**PLANNING BOARD AGENDA
MAY 18, 2016 – 7:00 P.M.**

RESPONSE TO COMMENTS PAT CLEARY DATED APRIL 13, 2016
ROONEY, 17 MILLER ROAD, TM # 86.11-1-18

**Re: Lake Plaza Shopping Center
983-1005 Route 6,
Mahopac, NY 10541
Tax Map #65.10-1-45 & 46 – Site Plan Review**

To: Carmel Planning Board
From: Richard J. Franzetti P.E. Town Engineer
Date: January 8, 2016
Re: Lake Plaza – Amended Site Plan 65.10-1-45 and 46

| SHEET NO. D-1 | |

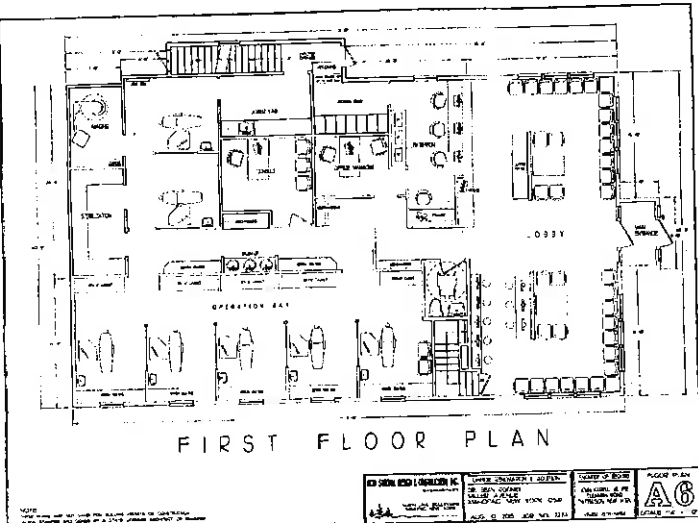
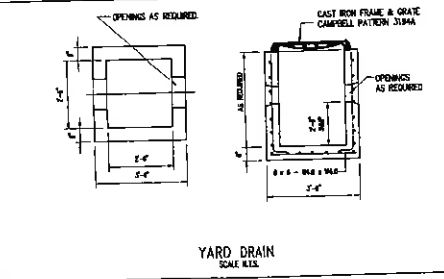
7. The wall will be visible from the bikeway. The wall will be a fieldstone wall, a detail of which is found on sheet D-1.
8. See attached letter from Dr. Rooney dated April 18, 2016 in this regard. The Site Plan Zoning table has been revised to reflect 6 employees which including the dentist requires 10 parking spaces, 13 are provided. It is noted that Mr. Rooney wanted to maximize the number of parking spaces serving the building.
